# NOTICE OF CHANGE TO NHBC STANDARDS AFFECTING DRIP DETAIL FOR RENDERED WALLS

## NHBC Standard 2025 - 6.11.7.1

### What's changed?

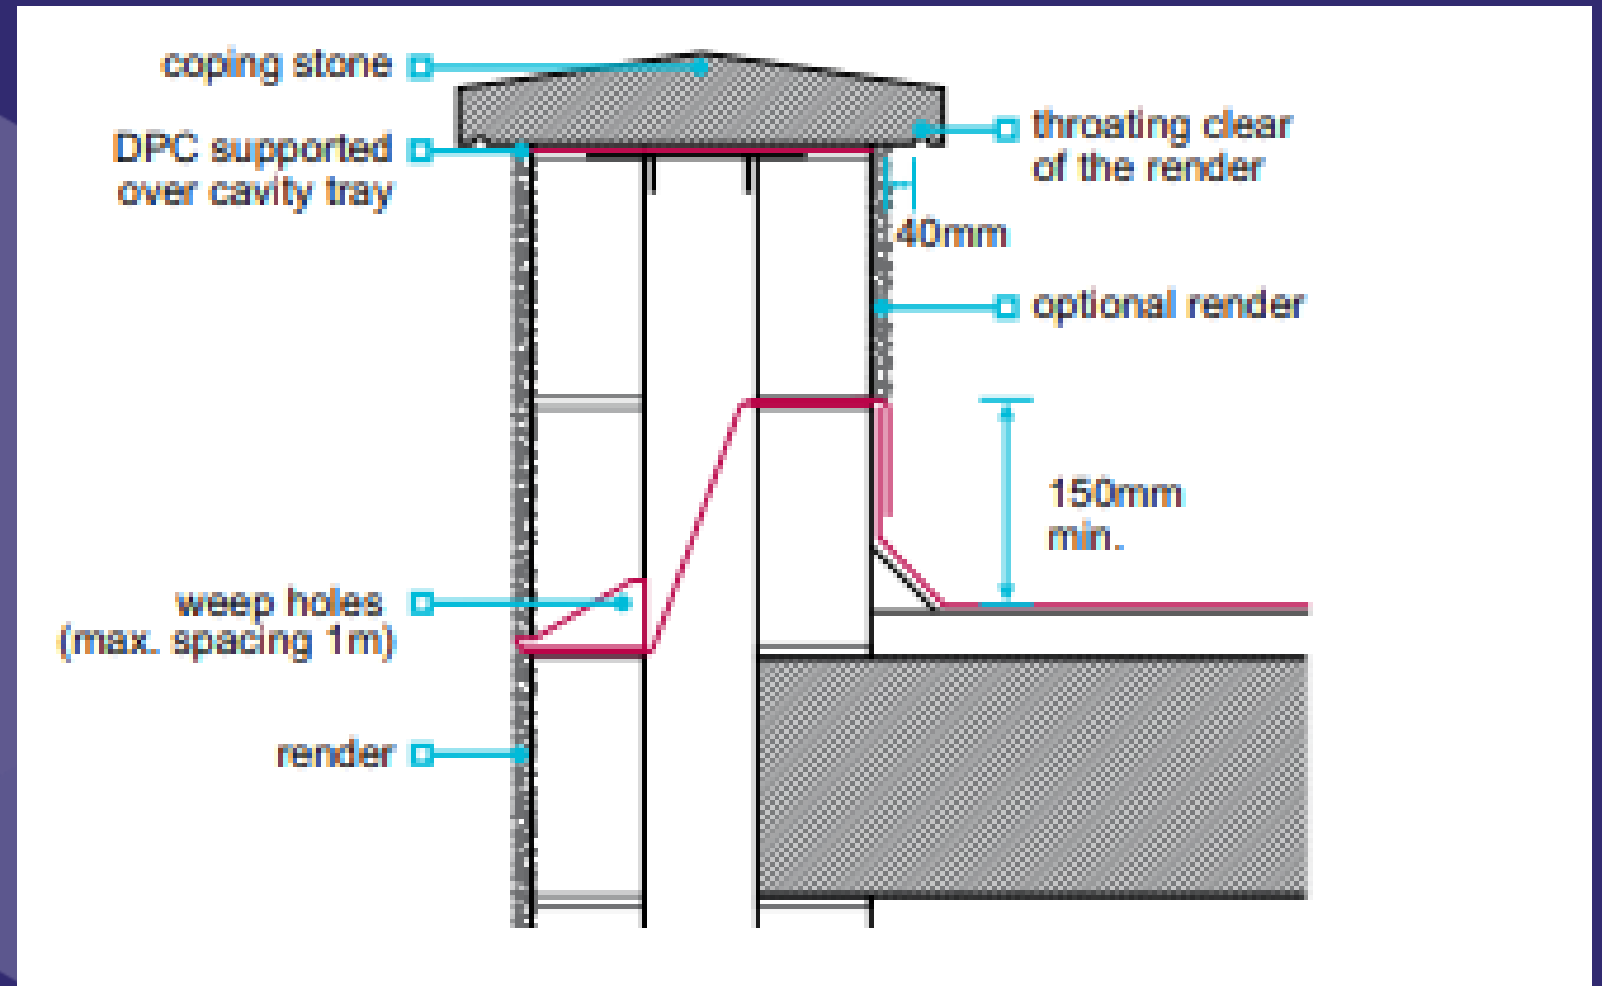
The previous NHBC standard stated that “A minimum 40mm projection with a throating or drip detail should be provided to all copings cappings and sills. “ The new standard states that the throating or drip detail should not be less than 40mm away from the face of the rendered wall. This additional distance to the drip detail will help to disperse water away from the rendered wall and prevent staining.

Render should be protected from damage by copings, cappings or sills made of a material of low permeability or with suitably detailed DPCs. All copings, cappings and sills should have an efficient throat or drip on the underside which should be not less than 40mm away from the face of the rendered wall. Extending sills or sub-sills beyond window reveals can help to disperse water and prevent staining.

We have designed a new sill detail to be compliant with the new standard, which is now available to order. Detail drawings are also available if required.
